2.0' CRITICAL DEPTH
1.80' NORMAL DEPTH
6" THICK WIRE ENCLOSED RIP RAP
DETAIL A
TYPICAL CHANNEL CROSS SECTION
SCALE: 1/8" = 1'-0"
APPROVALS - REVISION
City Engineer Date
Traffic Engineer Date
BENCH MARK: B.M. NO. 2-L23 Elev. 5756.82 cut on east P.C. of SE curb return at Skyline Road NE and Lawrence Drive NE.
APPROVED FOR CONSTRUCTION
CITY ENGINEER DATE
APPROVALS ENGINEER DATE
City Engineer
A.C.E.-Design
A.C.E.-Hydrology
Liquid Waste
Traffic
Water
REVISIONS
Designed by Drawn By Checked By Approved By
MURRAY-McCORMICK, INC.
ENVIRONMENTAL DESIGN
ENGINEERING · PLANNING · SURVEYING
GO REALTY
ORONA ADDITION
L23/DS
GRADING PLAN
DATE JULY 19, 1977
SCALE AS SHOWN

Re: Orona Addition, Albuquerque, New Mexico

Re: Orona Addition
Lot Ponding Requirements

DRAINAGE STUDY
ORONA ADDITION

GRADING PLAN

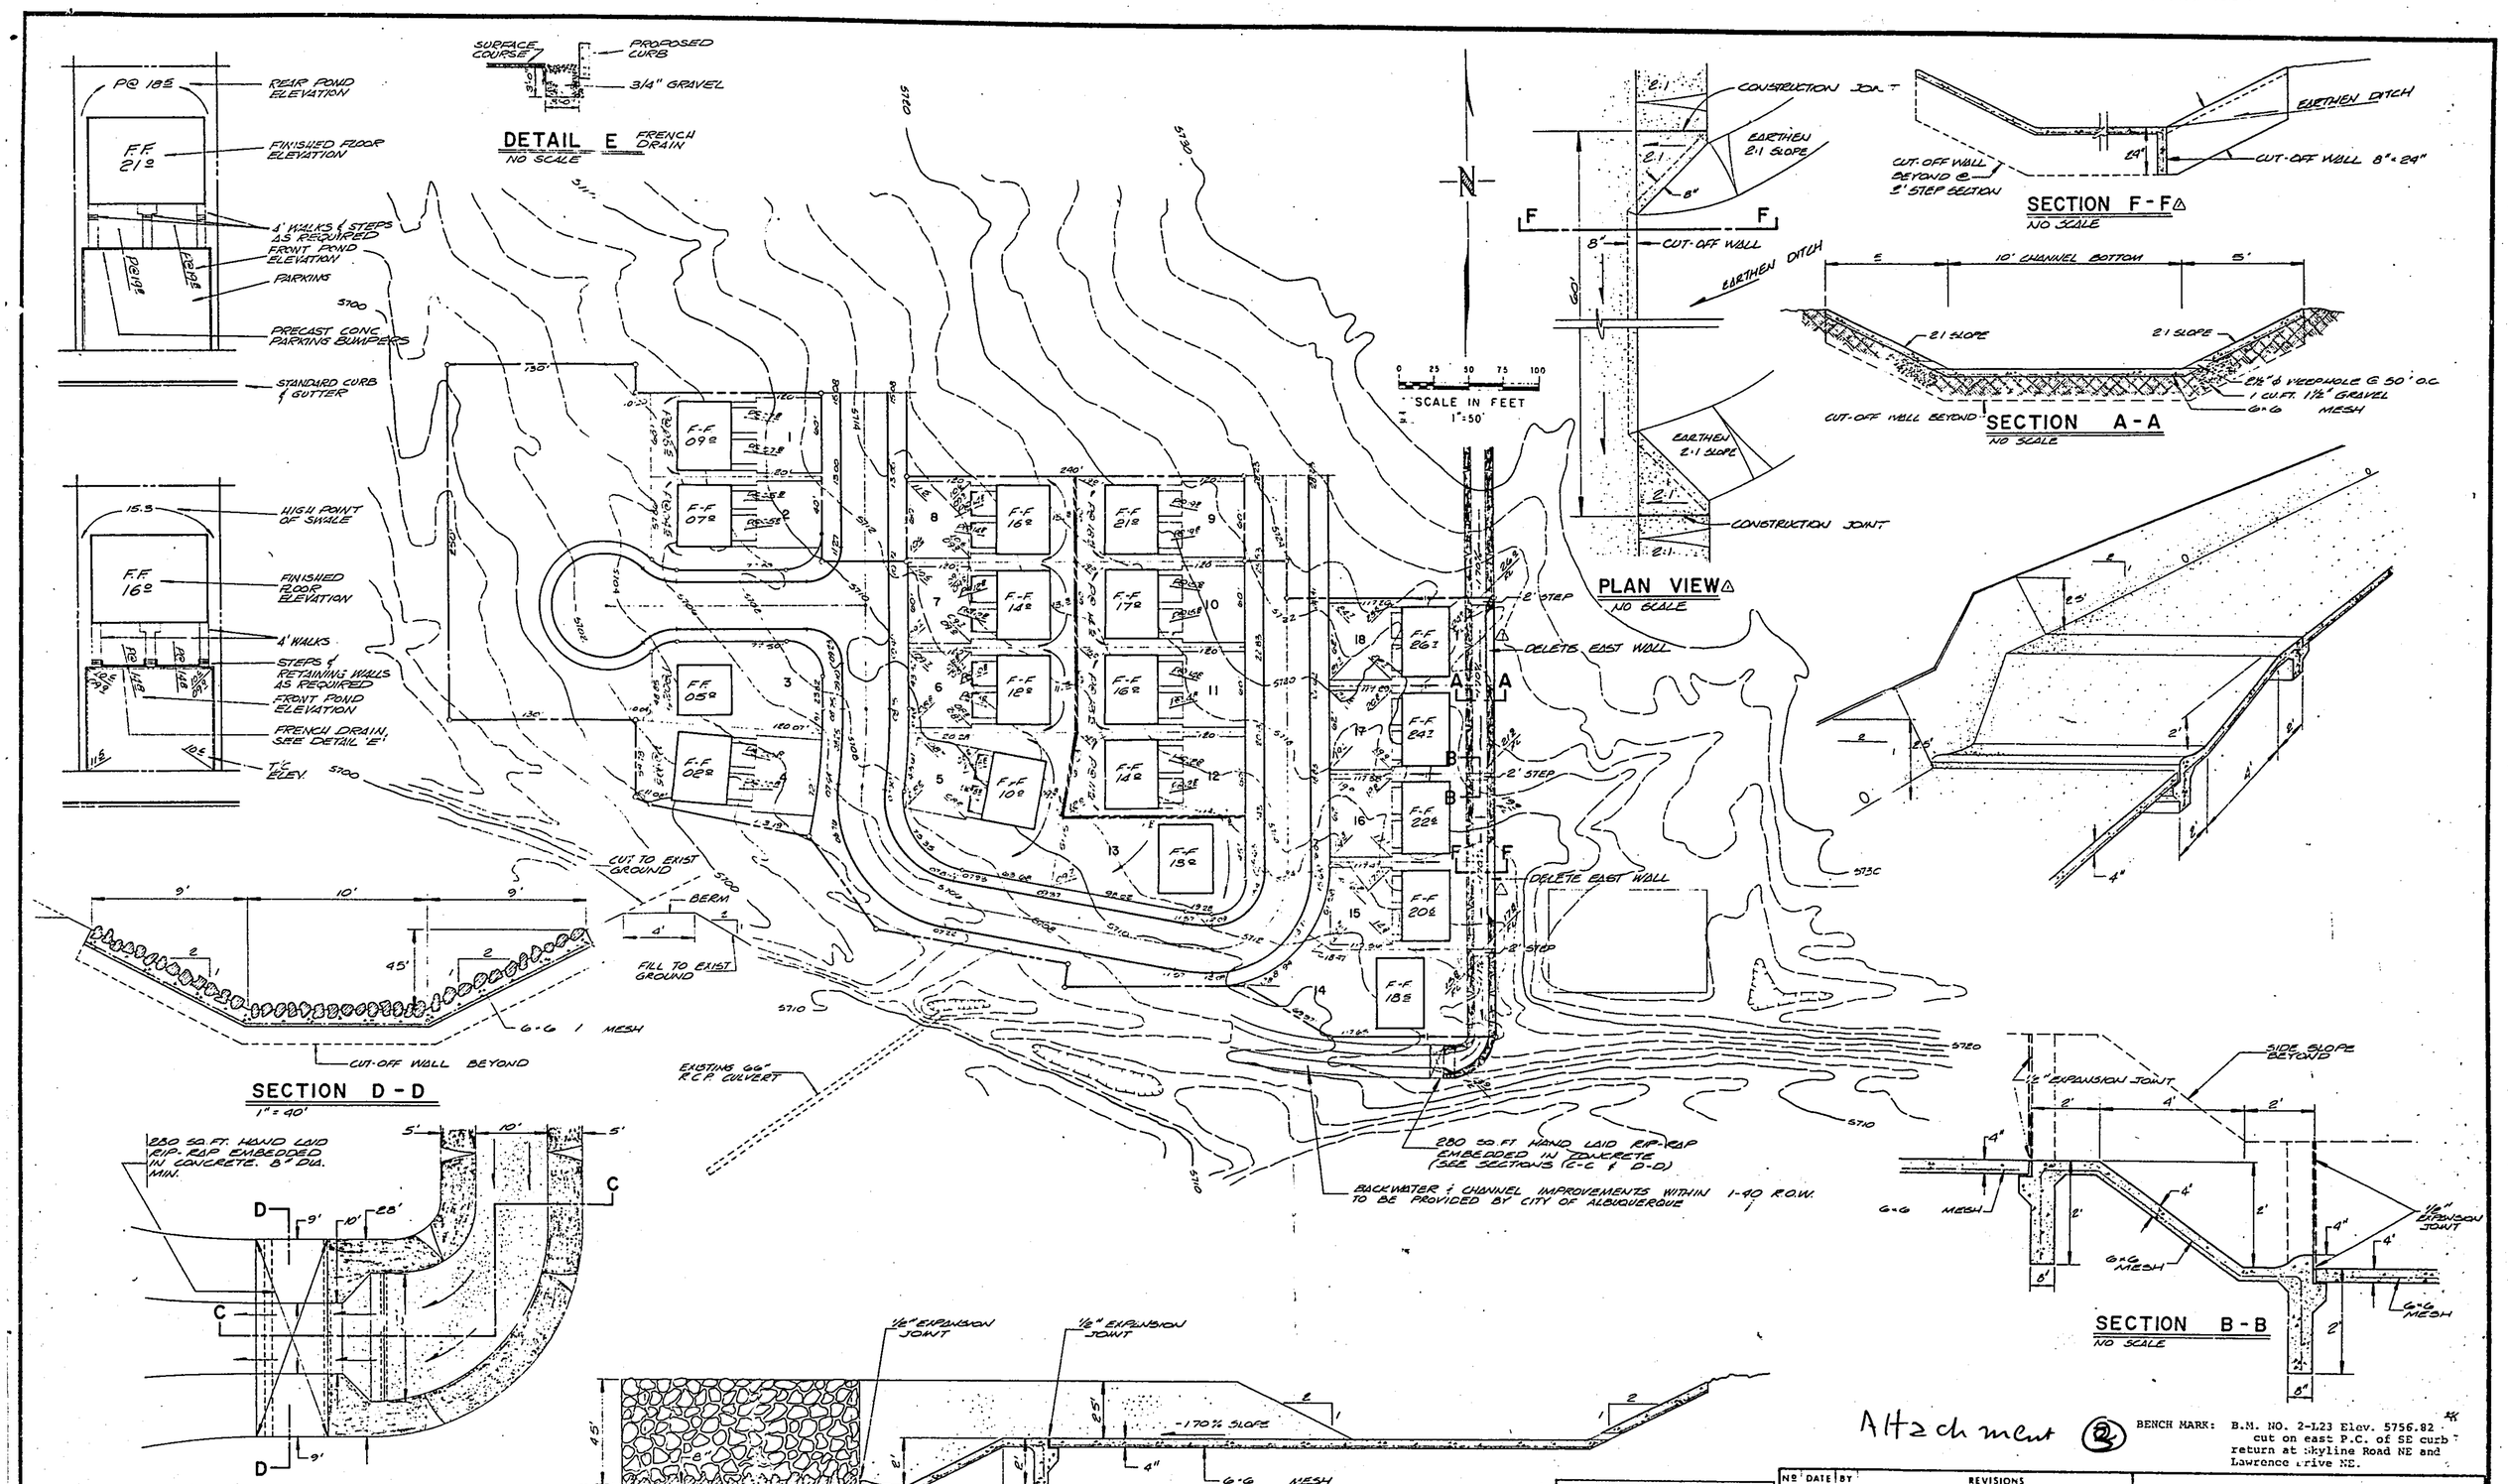
Nº	DATE	BY	REVISIONS
1	9/19/77	AA	REVISE PER HYDROLOGY REVIEW

FRENCH DRAIN DETAIL
ORONA ADDITION
WEST SIDE OF STREET

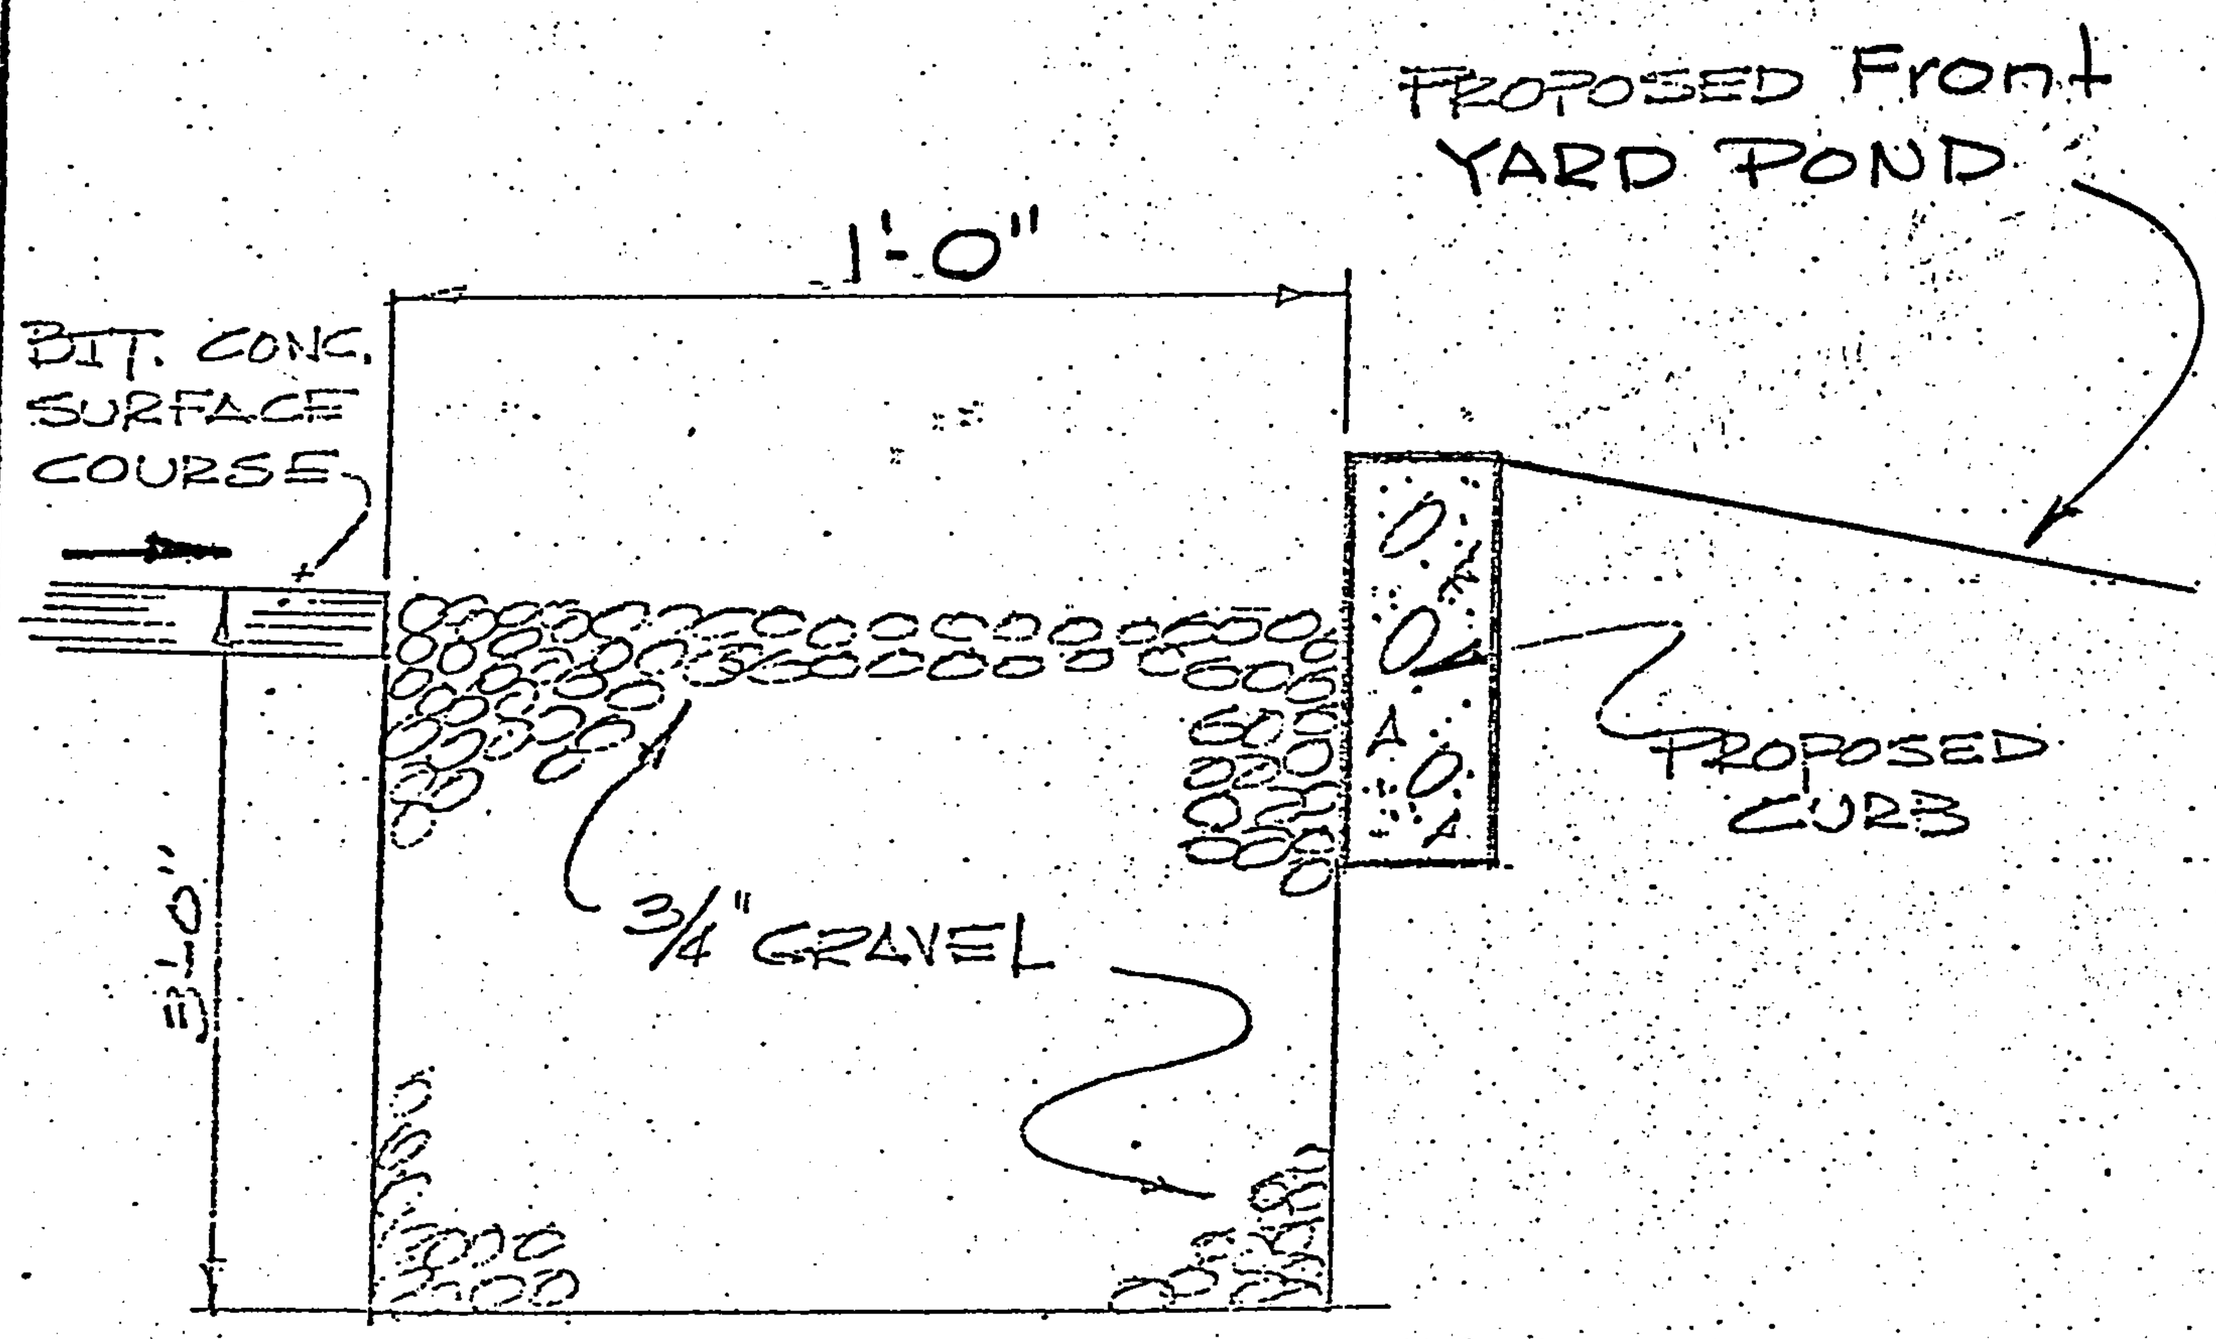
Those lots on the west side of the street should be graded such that the parking lot, roof, side and rear yards drain to a 650 cubic foot pond in the rear yard. This method will require the installation of precast concrete parking bumpers in lieu of curb to allow parking lot water to enter the ponds between building and parking lot.

FRENCH DRAIN DETAIL

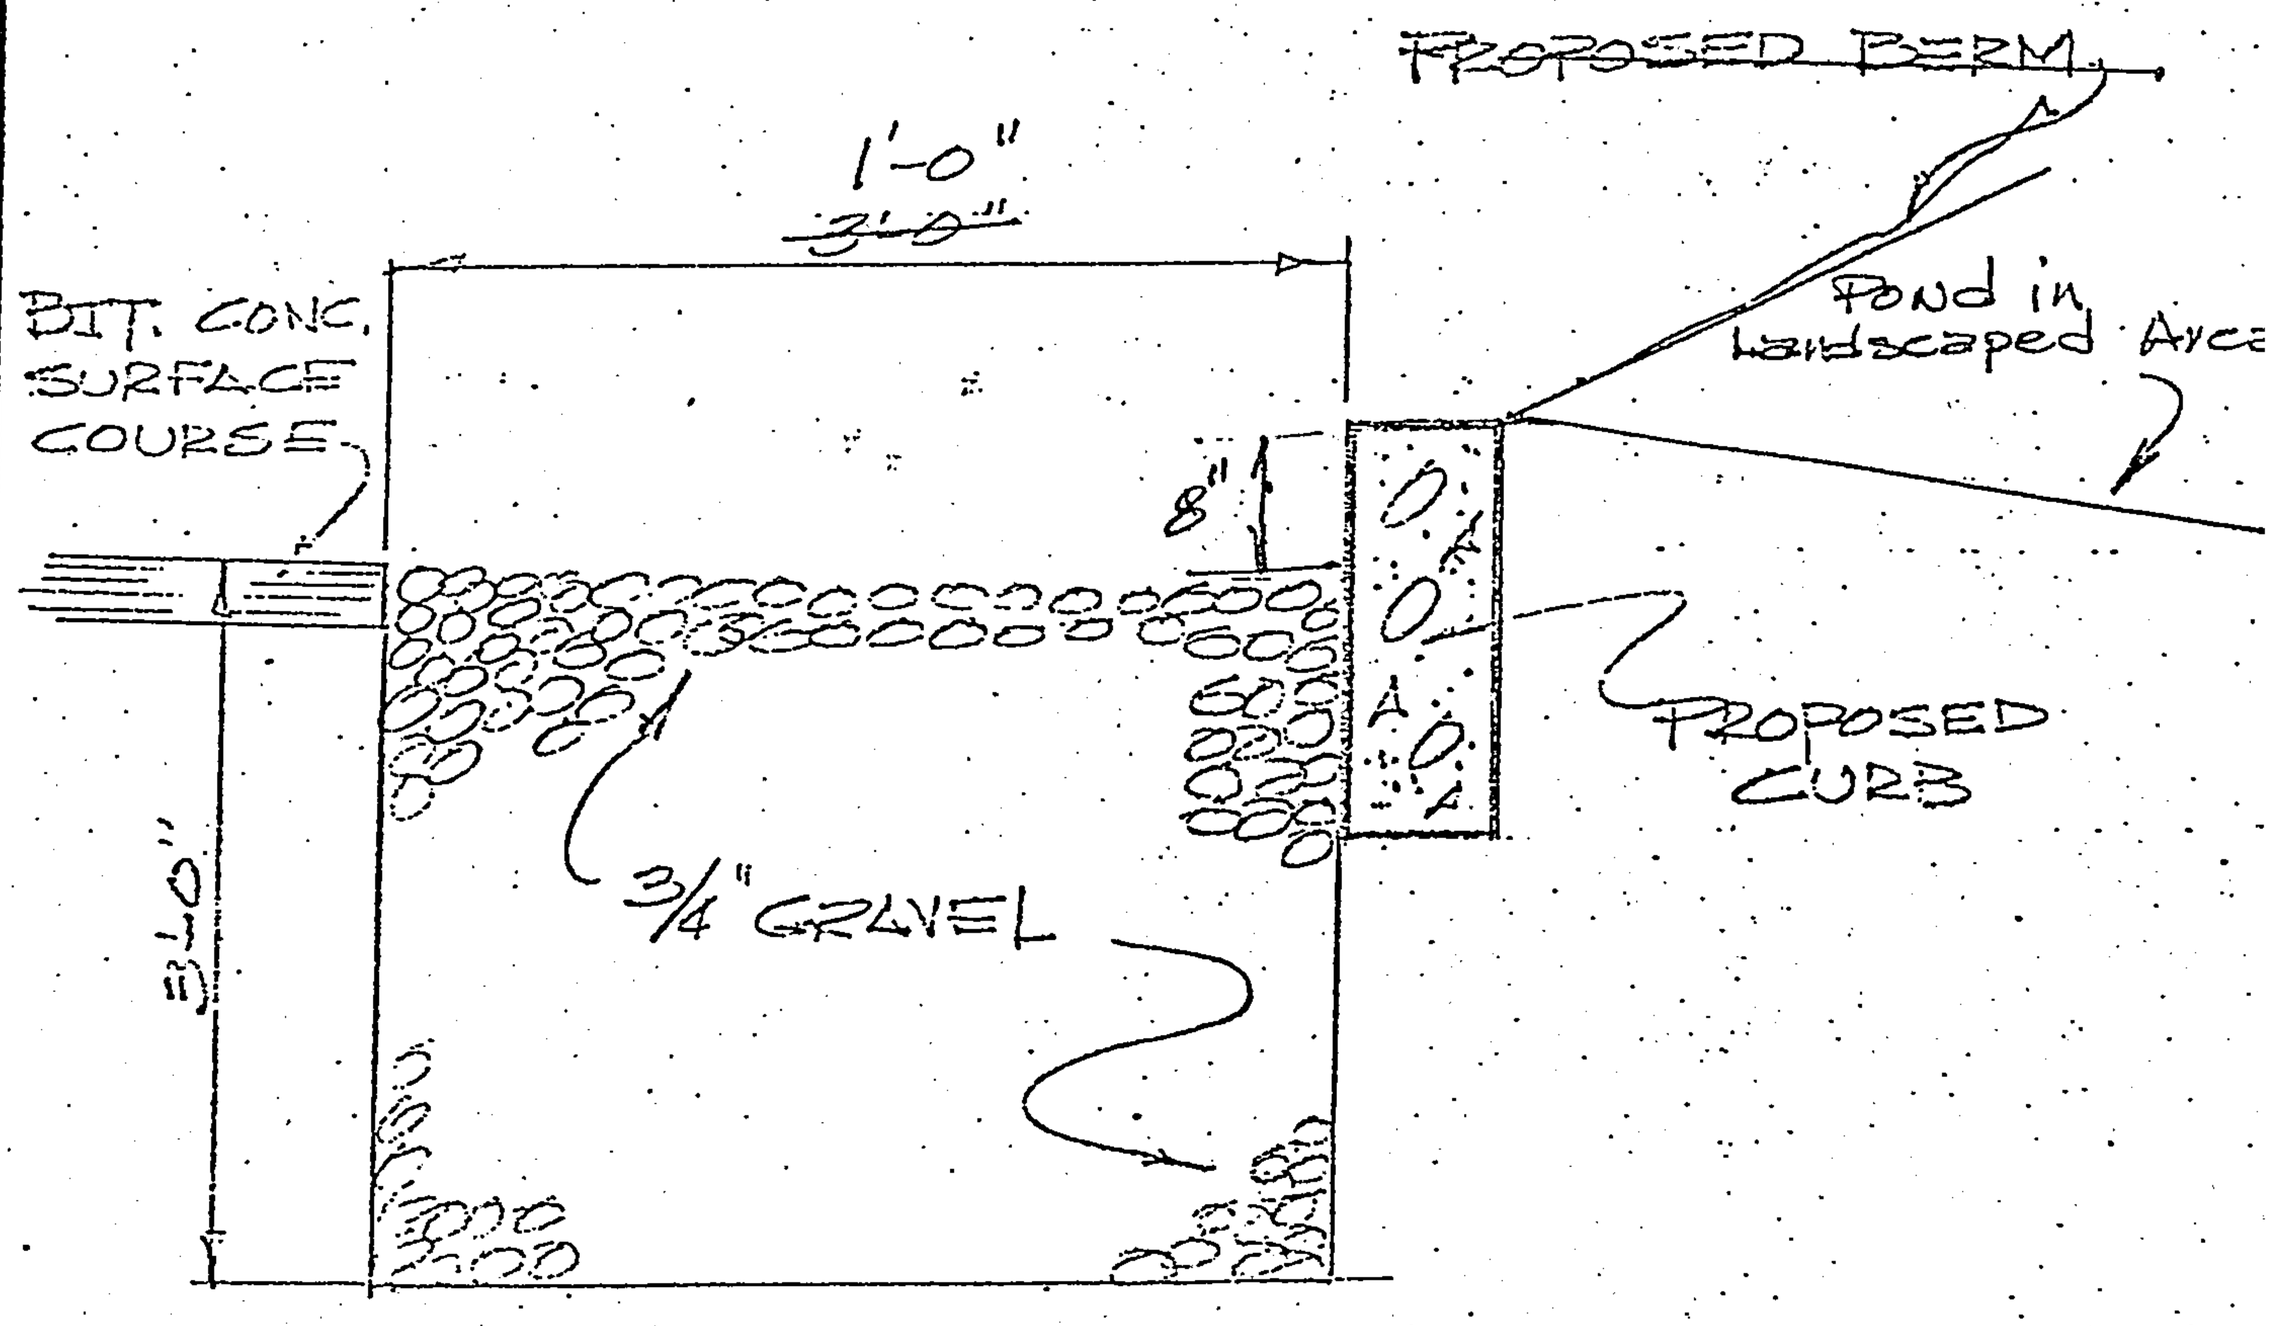
Due to the nature of the 4% slope from east to west it will be virtually impossible to grade and construct a uniform ponding system for all lots within the project. Therefore, it is recommended that 100 cubic feet of storage be provided within the lawn areas between the parking lot, building, and within the limits of the service walks. For those lots on the east side of the street, roofs, rear and side yard areas should be graded to drain to parking area. The parking area should then be back pitched to create an additional pond of 650 cubic feet adjacent to the wheelstop curb.and adjacent french drain.

Lots on East side of streets only.
